Reference: Addendum No. 03 to the Bidding Documents for:
North Regional Library
Roof Replacement
REI Project No. R25RAL-079

This addendum consists of 1 page concerning revised/added drawing sheets.
XR101 – “Roof Plan – Revision 1”

PROJECT NAME:
**WAKE COUNTY
NORTH REGIONAL
LIBRARY ROOF
REPLACEMENT**

SHEET TITLE
**ROOF PLAN -
REVISION 1**

DRAWING
XR101

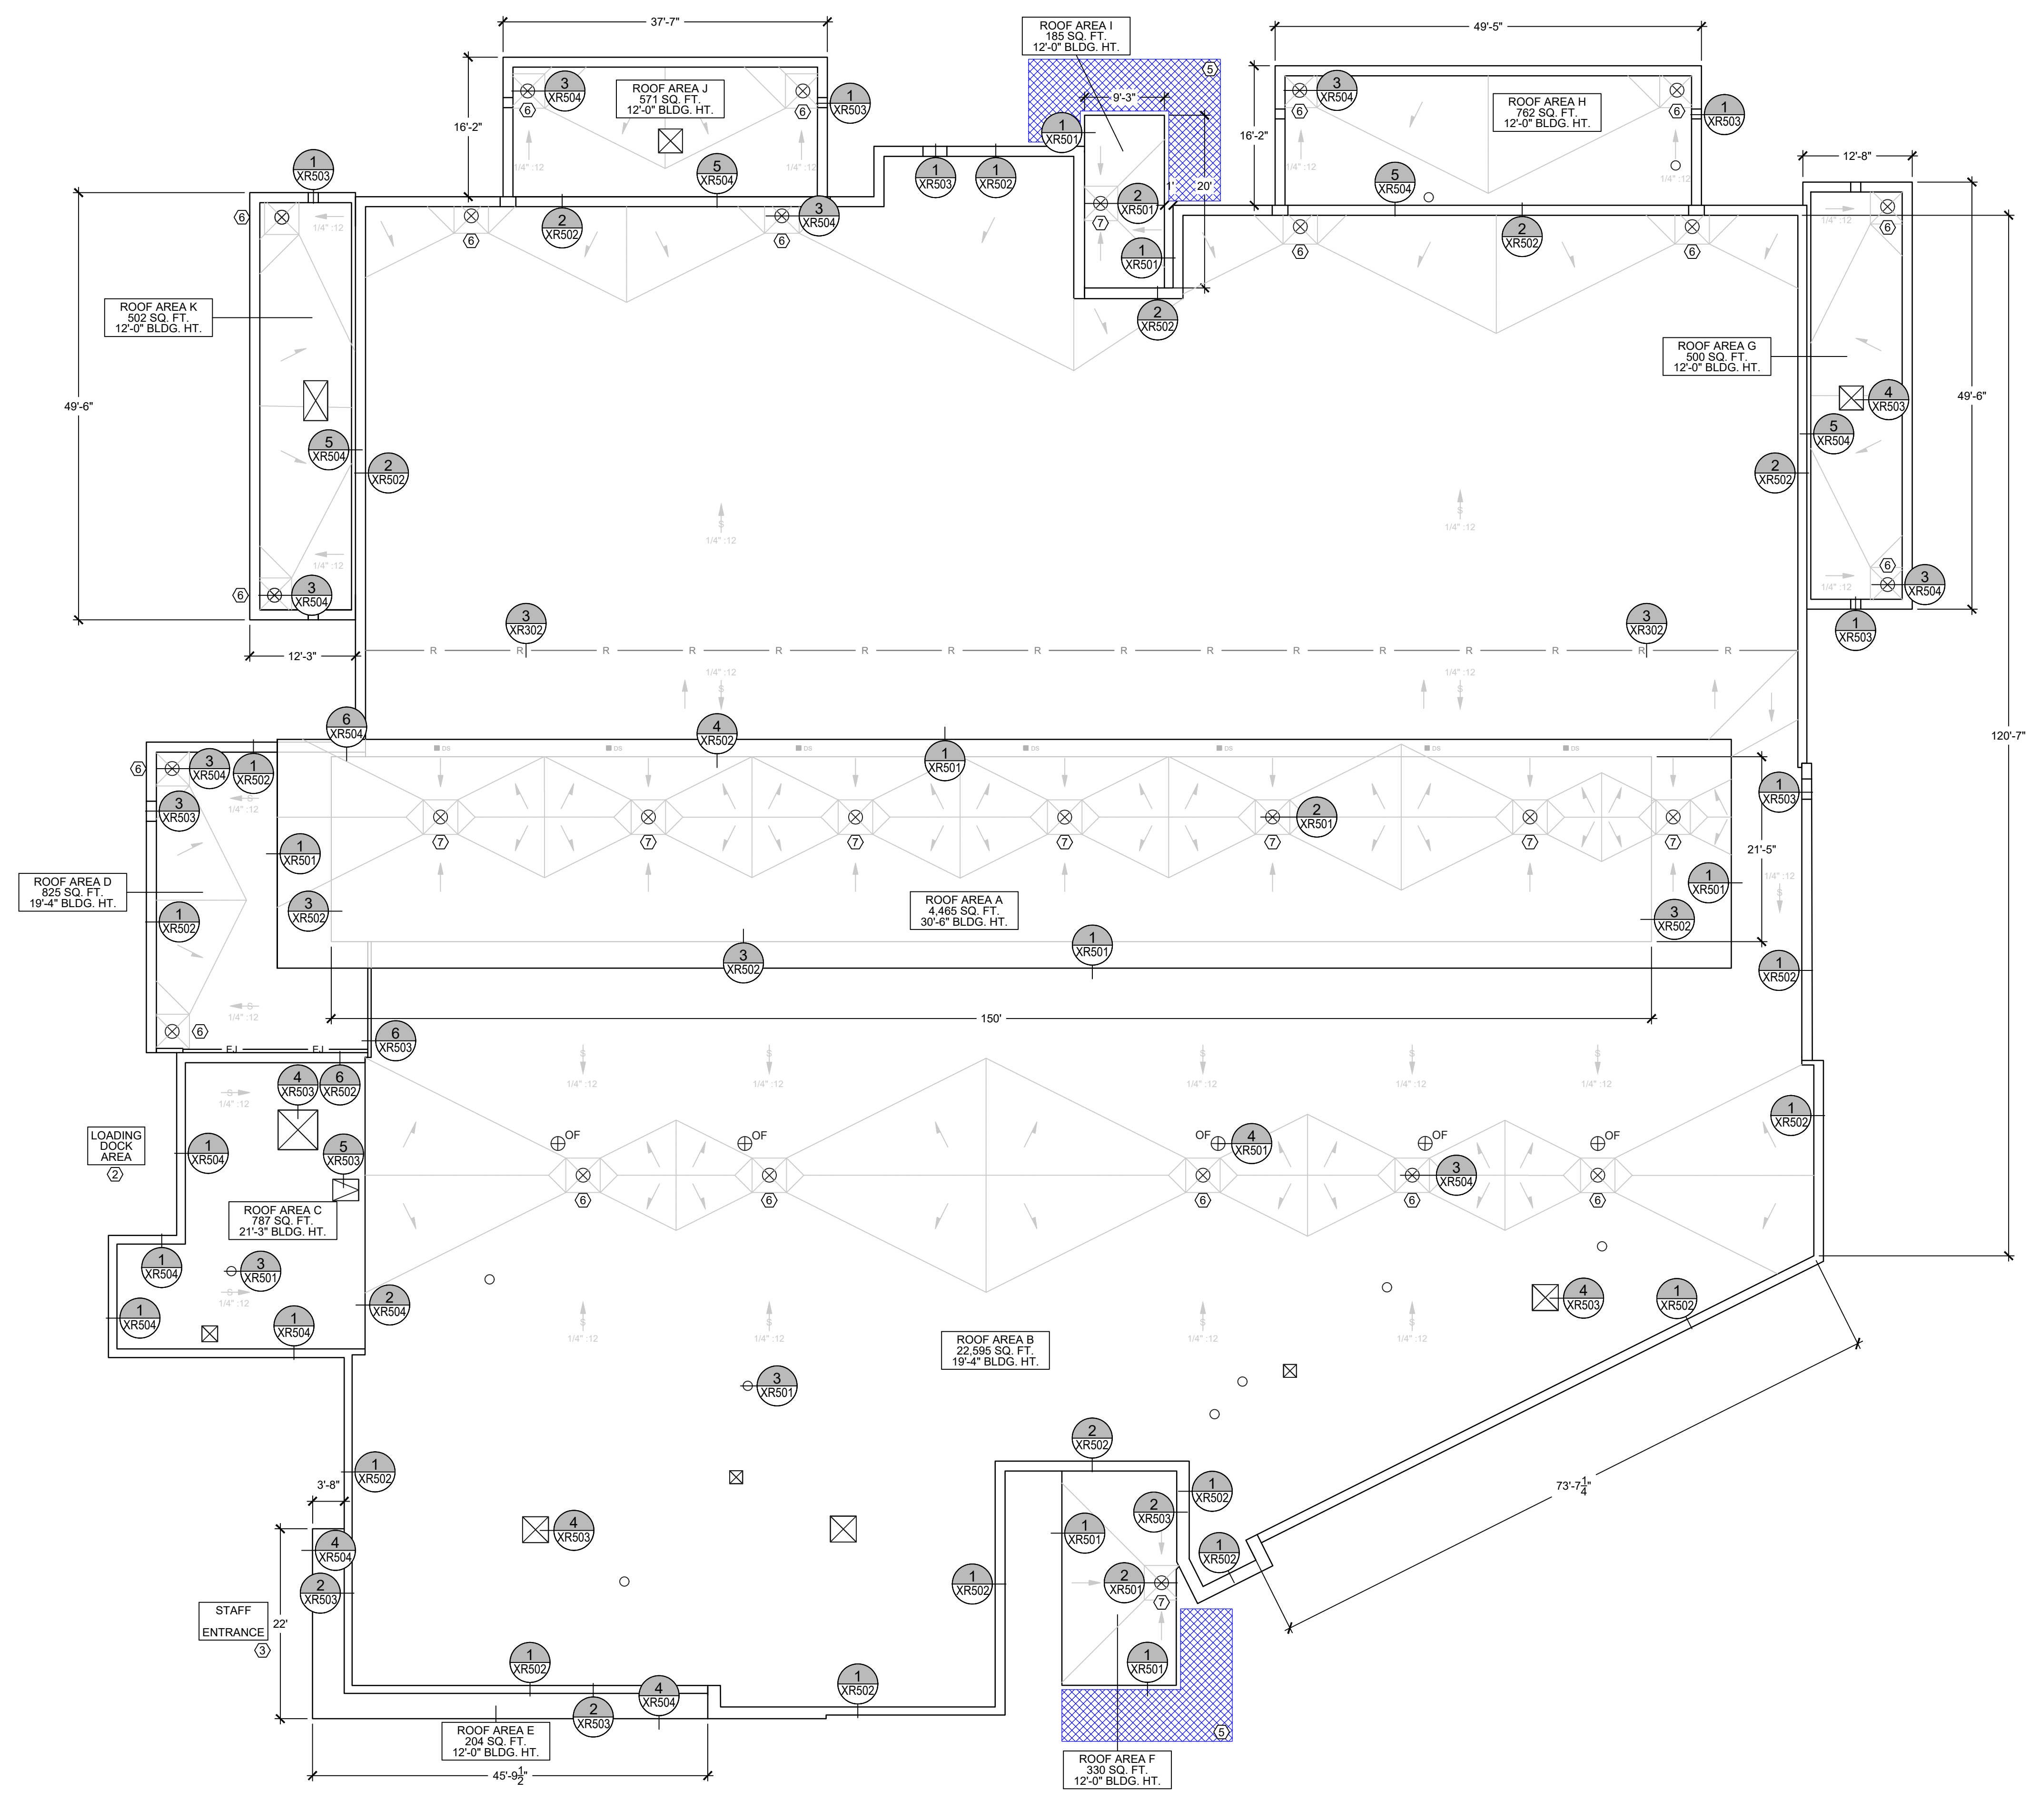
9. ADD: In Specification Section 07 54 00 – “Thermoplastic Single Ply Roofing”, add Item 2.4 A 4: “Flex RS 230 Flash”.
10. REPLACE: Replace existing Drawing Sheet XR101 – “Roof Plan” with attached Drawing Sheet XR101 – “Roof Plan – Revision 1”.

1. **Bidder Question No. 1:** Specification Section: 22 14 26, Paragraph: -, Drawing Reference: XR101, Detail No(s): 4/XR501 and 3/XR504.
 - a. Question: The specifications mention full drain bowl installation. I am trying to discern which drains are being replaced and the extent of plumbing piping required. Are all drains in B, D, G, H, J & K being fully replaced?

- REMOVE ABANDONED PENETRATION AND PROPERLY REPAIR ROOF DECK.
- LOADING DOCK AREA: PLACE BARRIER / BLOCK OFF ACCESS WHILE WORKING ABOVE THIS AREA.
- STAFF ENTRANCE: WORK ON THE CANOPY AT THIS AREA (ROOF AREA E) MUST BE PERFORMED OUTSIDE OF LIBRARY BUSINESS HOURS.
- VEHICULAR BOOK DROP: WORK ON THE CANOPY AT THIS AREA (ROOF AREA E) MUST BE PERFORMED OUTSIDE OF LIBRARY BUSINESS HOURS.
- PROVIDE OVERHEAD PROTECTION AT ENTRANCES.
- PROVIDE NEW ROOF DRAIN AND ASSOCIATED PIPING.
- PROVIDE RETROFIT ROOF DRAIN.

- b. Response: Provide new roof drains and associated piping in accordance with Detail 3/XR504 at Roof Areas B, D, G, H, J, and K. Provide retrofit roof drains at Roof Areas A, F, and I in accordance with Detail 4/XR501. Sheet XR101 has been updated as a part of this Addendum No. 2 with Sheet Notes 6 and 7 indicated the design intent for each roof drain.
